# 305 S. Congress PUD

Presentation  
to the  
Parks and Recreation Board  
September 14, 2021

# Staff Evaluation - Environmental

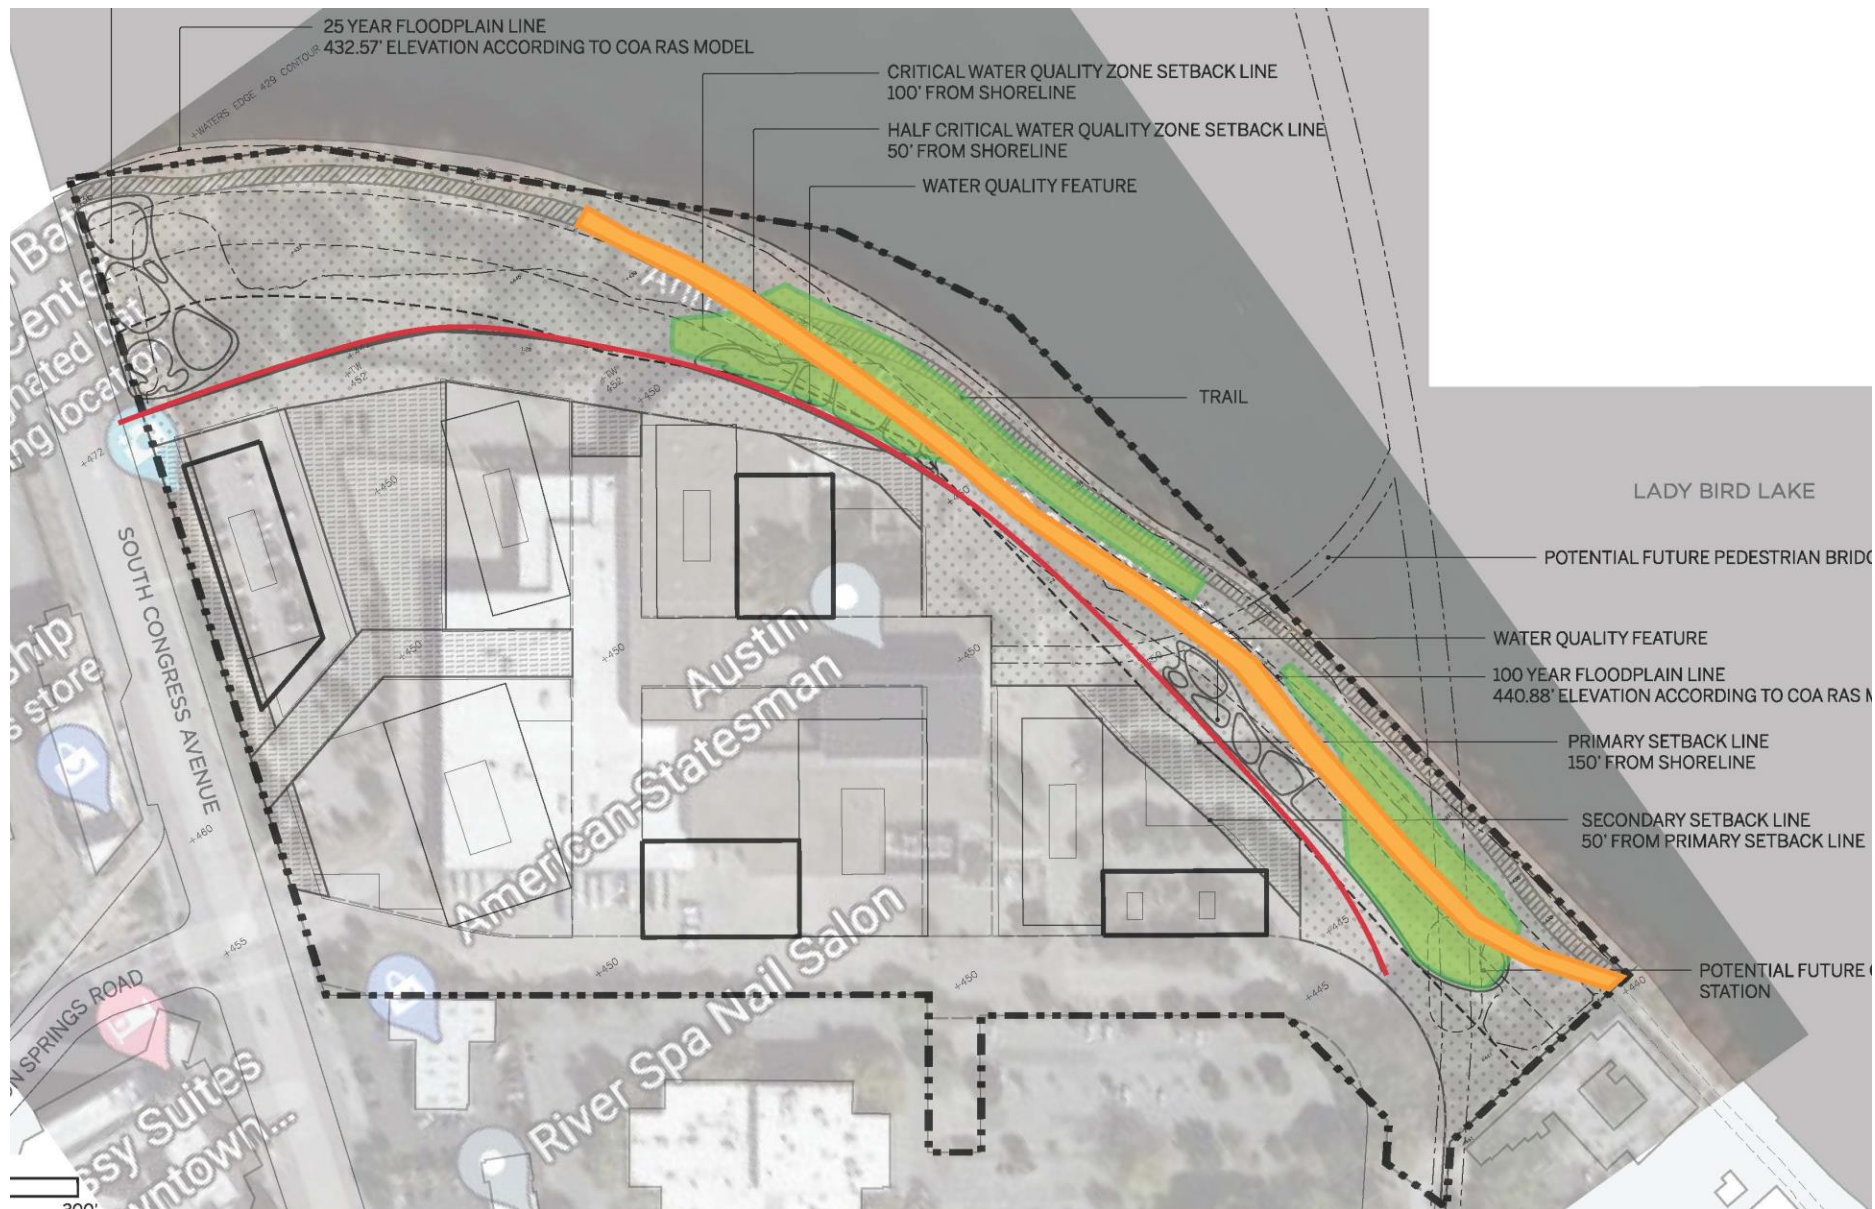
There are areas on the west side of the property that are more suited to programming. This area near Congress bridge is full of ragweed and has no trees, it is where shoreline access including the pier and stairs should be located.

There are areas throughout the shoreline that are eroding and need to be restored and protected with a split rail fence.

There are areas along the trail where water is running downhill across the trail and causing erosion along the shoreline.

On the eastern half of the property, the trail lies on the edge of the shoreline and is causing erosion downslope. Staff suggests that the trail be moved a minimum of 25' from the shoreline in these areas. The area between the trail and the shoreline should be restored.

In exchange for denser development on the west side for bat viewing, staff proposes moving the trail off the shoreline as shown. Staff also proposes moving all water quality ponds as shown and integrating the rain gardens with restoration, alleviating the need for a deep biofiltration pond in the bat viewing area.

# Staff Evaluation - Parkland

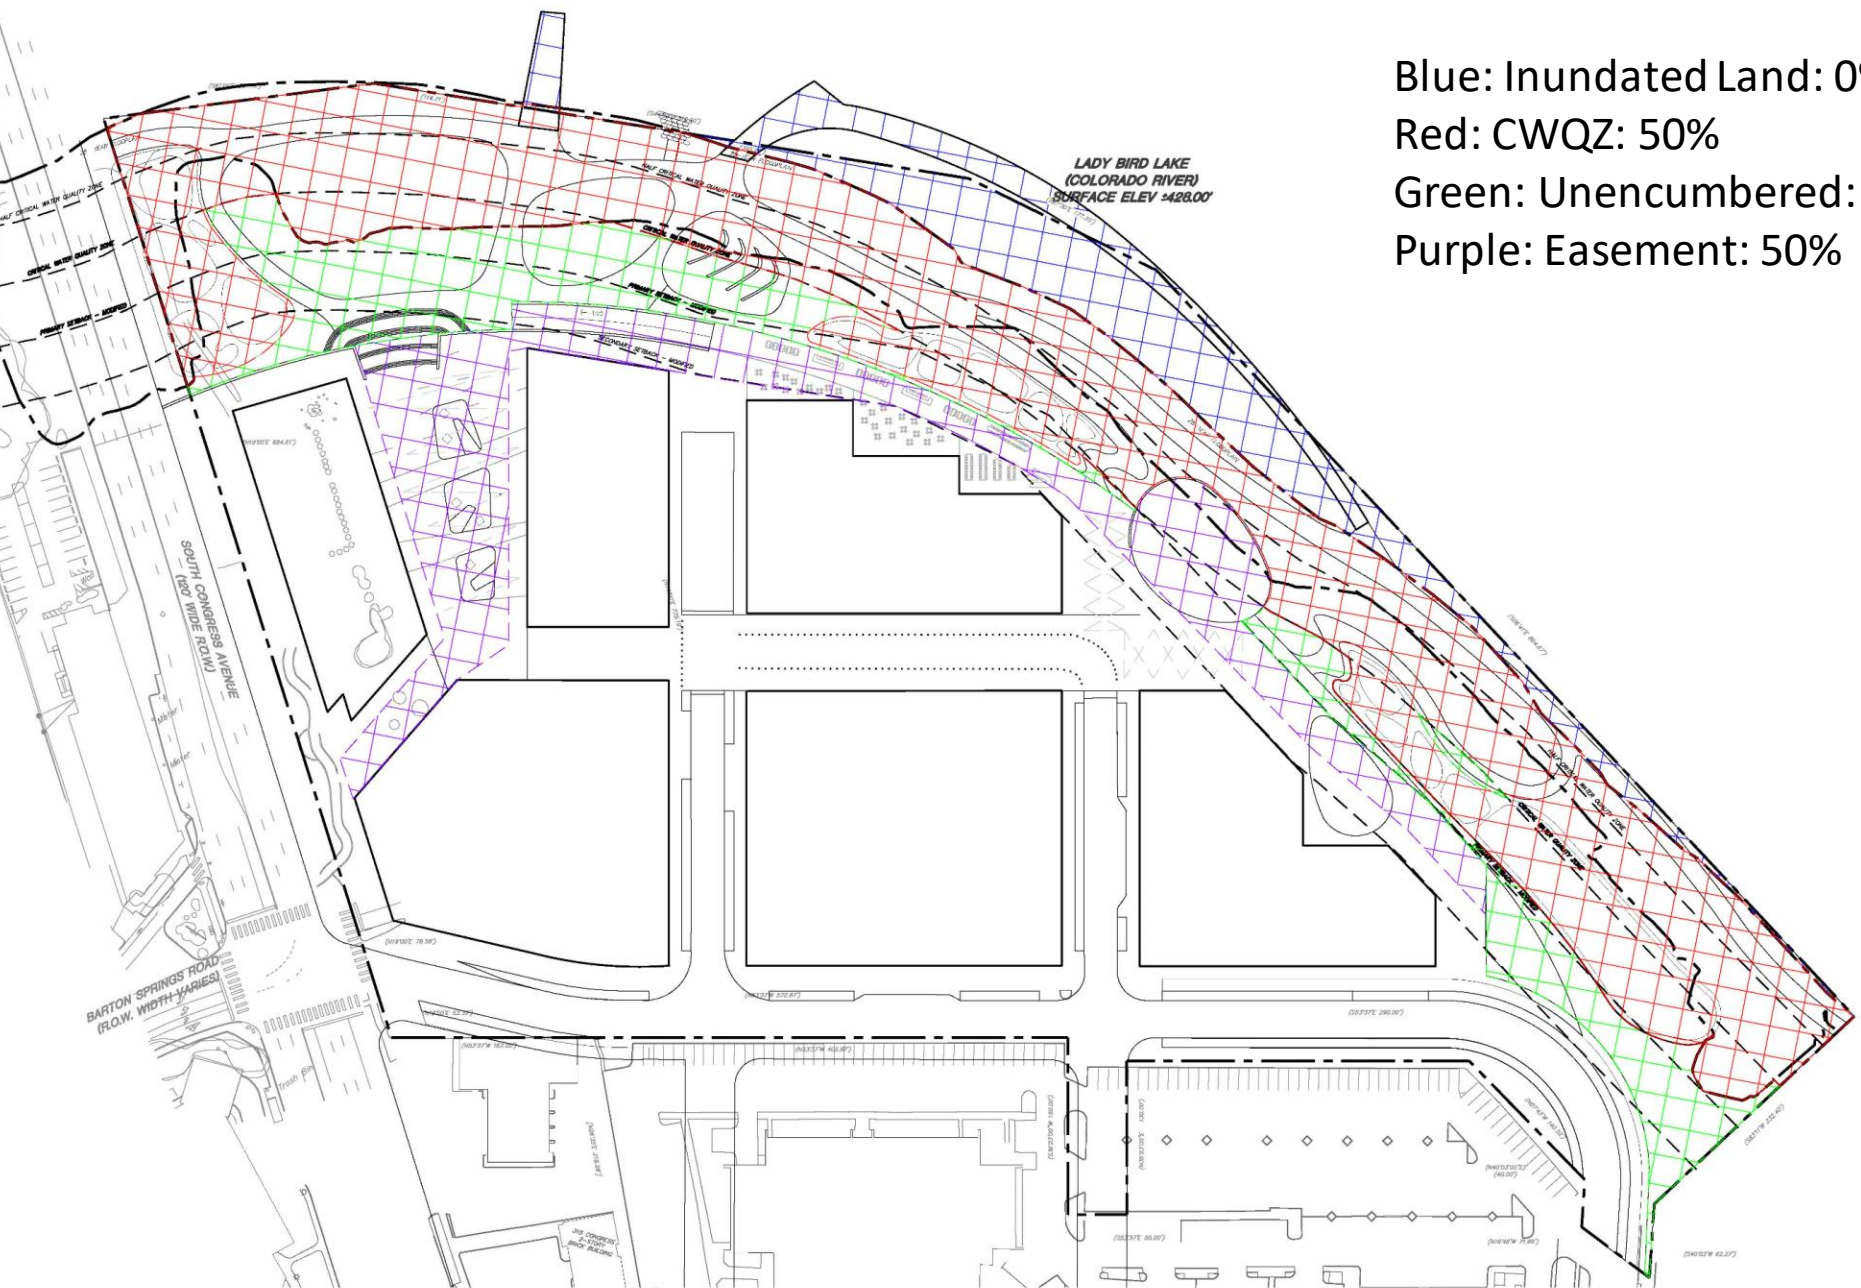
1. Applicant has committed to deeded parkland, with conditions. Reservation of rights to program or restrict programming would fall under Parkland Improvement Agreement.
2. Timing for dedication and park construction is unclear. Trigger needs to fall towards beginning of construction of a phase.
3. Specificity of commitment to build park amenities. Current code would require park development; superiority would mean committing to build in excess, on a per unit basis. (e.g. >+\$200 per unit), and making improvements clear on plans.
4. Ponds in Parkland, especially if fenced and not designed as amenities. Special focus on Bat Viewing Area.
5. New access from S. Congress to trail and bat viewing via Great Steps. Access should be fully public, direct, and ADA accessible.
6. Land Uses in parkland – commercial uses should be removed.
